**STAFF REPORT: FEBRUARY 8, 2023 MEETING**

**APPLICATION NUMBER: 23-8204**

**ADDRESS: 7908 – 7912 ST. PAUL**

**SCOPE: REMOVE WOOD SIDING\*, INSTALL SYNTHETIC SIDING, REPLACE WINDOWS AND DOORS, REBUILD PORCH**

*Staff photo, January 2023*

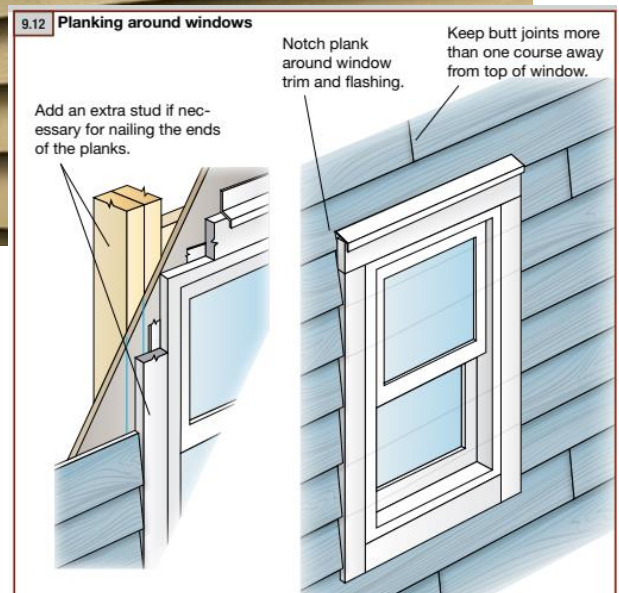
- The applicant's photos give evidence of occasional missing boards and flaking paint; however, the majority of the siding was intact and very likely repairable. This house was constructed in the early 20<sup>th</sup> century of old growth lumber which was exceptionally dense and highly durable.

- As discussed under staff observations, the dimensional difference of the front and side elevation siding is a distinctive character-defining feature of this house and immediately identifies its era of construction. The applicant confirmed the siding on the sides and rear of the house had a 5" reveal; the siding on the front elevation had a 3" reveal.

- The applicant stated the proposed Hardie lap siding can offer a 4" reveal for the front elevation and a 5" reveal for the side and rear elevations. While this offers some dimensional change, the 2" difference in dimensions for the historic siding is distinctly noticeable; a detail that would be lost (or significantly minimized) with the Hardie siding.

*Google street view*

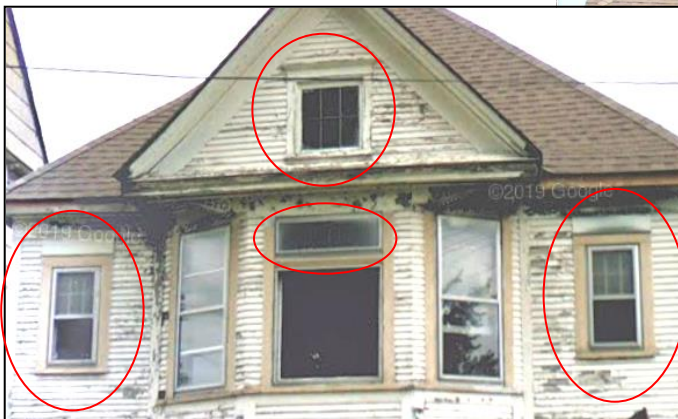
- The applicant proposes to replace all of the windows on the house, with the exception of the leaded glass transoms in the front elevation bay windows. Most of the openings are one-over-one wood double-hung sash, but there are a few openings on the front and side elevations that retained six-over-one double-hung units and awning windows with a unique muntin pattern. The images above show the windows that have divided and leaded sash, however, the six-over-one windows and the upper awning window are currently not in their respective openings (visible in photos on page one and six, respectively).

*Anderson 100 series single-hung unit*

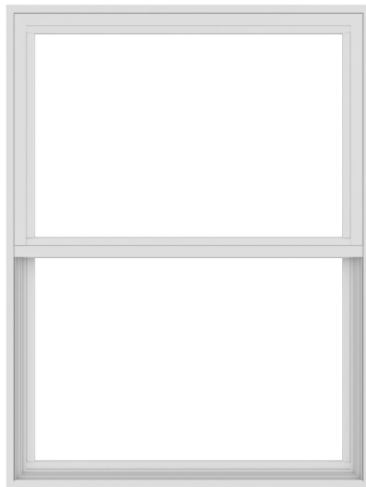
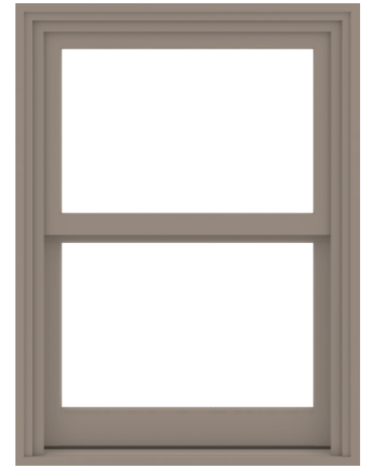
- The applicant has selected Anderson 100 series windows. This is a Fibrex product and is advertised by the company as “the smart alternative to vinyl”.
- This window is offered as a single-hung operation, not double-hung. It is important to note that a single-hung unit offers a different appearance than a double-hung unit as the upper sash is fixed and welded to the window frame, creating a flat surface at the upper sash. Example is at below left exterior view. Staff used another Anderson double-hung as a comparison of dimensionality and difference of planes. *Please note:* each window manufacturer offers different window frame profiles and dimensions for their double-hung window lines.

The upper sash is outlined, yet is fabricated in the same plane as the outer frame. This makes the upper sash appear to be a component of the frame.

The star identifies the operable upper sash. It is recessed from the window frame and adds a dimensional relationship similar to historic window units.

- The owner submitted dimensions of an existing wood double-hung unit, and submitted only a few close-up photos of the conditions of some sash units that had already been removed from their respective openings. It is still staff’s opinion the existing sash are not deteriorated beyond repair, and that the selected window line, through limits of its fabrication and materiality, cannot match the operation and dimensionality of the existing windows.

Component	Existing	Replacement	Dimensional Change	
Top Rail	1-3/8”	3-1/8” 2-5/16”	Replacement 2” thicker.	The proposed windows are single hung, and do not have a traditional top rail. This figure represents the exposed portion of the top of the window frame.
Meeting Rail	2-3/4”	2-3/16”	Replacement 9/16”-approx. 1/2” thinner	
Bottom Rail	2”	1-7/8”	Replacement 1/8” inch thinner	
Stile

Applicant photo and drawings; photo at right is an enlarged Google street view from 2013.

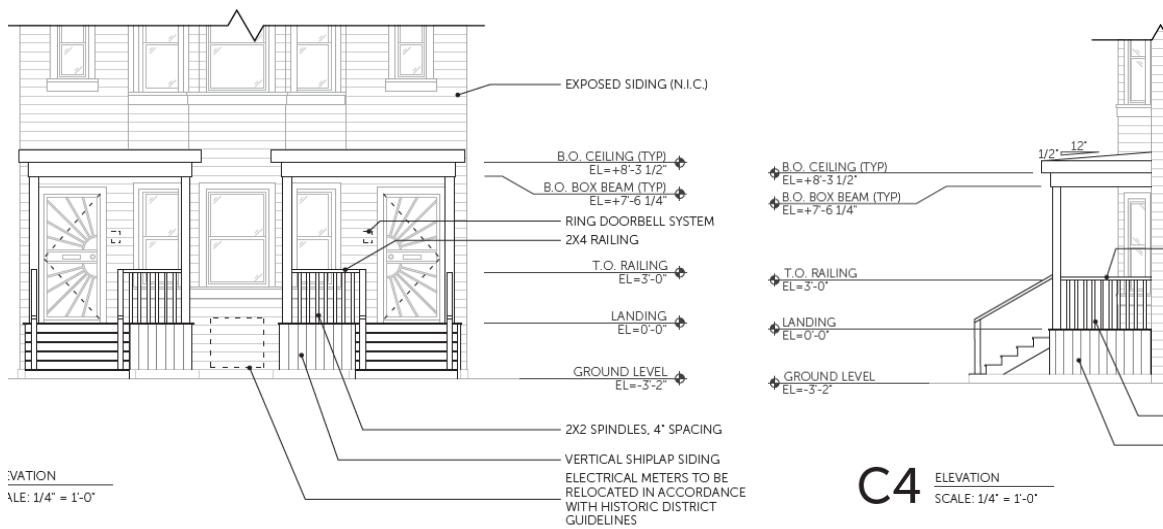
- The issued Certificate of Appropriateness for the two front porches required the outer posts be constructed to match the existing interior corner posts. Currently all posts have been removed from the porch. The drawing on the following page shows unadorned (and not dimensioned) posts.
- The 2018 approved porch railing was to be similar to a historic design with square spindles affixed within a top and bottom rail that terminates at square corner posts. The railing shown on the drawing is a contemporary deck railing and not appropriate for a front elevation porch of an early 20<sup>th</sup> century house.
- Staff inquired with the applicant if the drawings were a change to the design or a drafting error. The applicant confirmed the drawings don’t reflect what will be constructed.

- The porch corner columns will match the previous interior corner columns in dimension and design,
- The porch and stair railings will have straight spindles, top and bottom rails, and square corner posts.
- The porch components will be left to dry for one to three months before painting; and will be painted C4 Yellowish White.
- Revised plans noting all of the above conditions will be submitted for staff review prior to pulling a permit.
